CNRO-2006-00014

SUBJECT: Supplemental Information, Response to Request for Additional
Information Regarding the Grand Gulf Early Site Permit Final Safety
Evaluation Report (TAC MC 1378)

1. Responses to NRC Questions for Clarification Regarding the SERI February 22, 2006 Response to a Request for Additional Information on the Grand Gulf Early Site Permit Final Safety Evaluation Report.

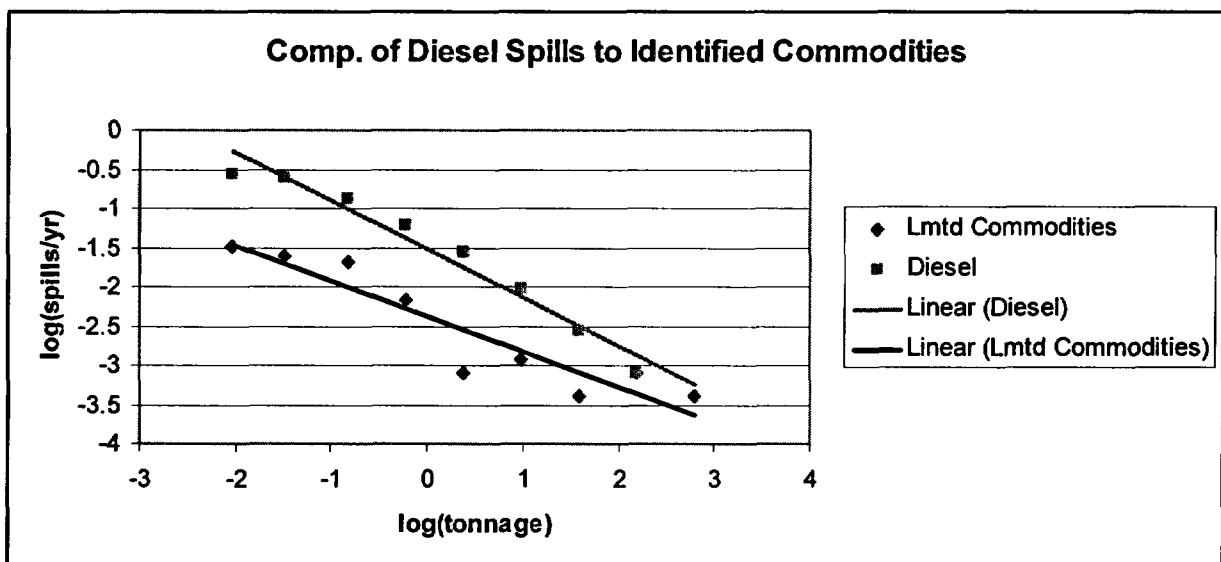
4. Page 22, 2.1 Spill Frequency Assessment: What is the basis for excluding spills involving commodities such as chlorine, coconut oil, diesel, lubricating oil ,etc? It is reasonable to expect a spill being the result of some sort of loss of tankage integrity (e.g., puncture, rupture). Hence, there is no apparent functional relationship between the type of commodity and the initiation of a spill in the event of a barge mishap. Exclusion of spills on the basis of commodity type can lead to a significant underestimating of the spill frequency.

There are two ways to have approached the spill frequency. One is on a spill per vessel basis. Then it would make sense to include all spill types, generate a per vessel frequency, and then multiply by the number of vessels. This is not what was done in the analysis of Reference 1. Rather, a spill of combustible contents per river mile frequency was calculated. The advantage of this approach is that it is not necessary to know the number of vessels involved. If, in the approach of Reference 1, a total spill per river-mile frequency was calculated by including chlorine, coconut oil, diesel, lubricating oil, etc., the results would then have to be multiplied by the portion of spills that involved the commodities of interest (e.g., gasoline, benzene, etc.), and the exact same final result would have been obtained. That is, the spill frequency may go up by a factor of X, but the portion involving materials of concern with would be 1/X, and these numbers would be multiplied together.

The question might then be asked why incident data for distilled fuel oil (DFO) was included in the analysis of spill frequency. DFO was included initially because it considered to be a possible plume or detonation source. Once DFO was out of the plume and detonation calculations, consideration was given to removal of DFO spill incident data from the spill database. However, the additional DFO spills (128 out of 255) are effectively cancelled out when multiplied by the fraction of vessels containing gasoline, benzene, etc. Since the DFO spills amounted to 128/256 (0.50 of the total) and the percentage of DFO is 0.40 of the total quantities shipped, it is conservative to keep the DFO data.

As an example, consider the spill frequency versus tonnage relationship developed

in the RAI Response text (Section H). If the total number of spills in each bin is ten times greater, then the curve fit will be an order of magnitude greater ($f = 10 \cdot 10^{(-0.4871 \cdot \text{LOG}(\text{tonnage}) - 2.7457)}$). But then, when determining the fraction of spills that are one of the critical commodities, a multiplication factor of 1/10 would be applied, providing the same equation, $f = 10^{(-0.4871 \cdot \text{LOG}(\text{tonnage}) - 2.7457)}$ again.

Of course, the new spills may not increase each bin total by an identical ratio. If the new spills tended to be of a smaller size, they would tilt the curve fit such that it would have a more negative slope. Evaluation of diesel spills (all spills in the MislVslPoll database identified as diesel, some 2102 spills), show this is the case. A plot of curve fits to diesel spills and to the commodities previously identified is shown below. Since the diesel curve fit is steeper, it would be non-conservative to include diesel spills.
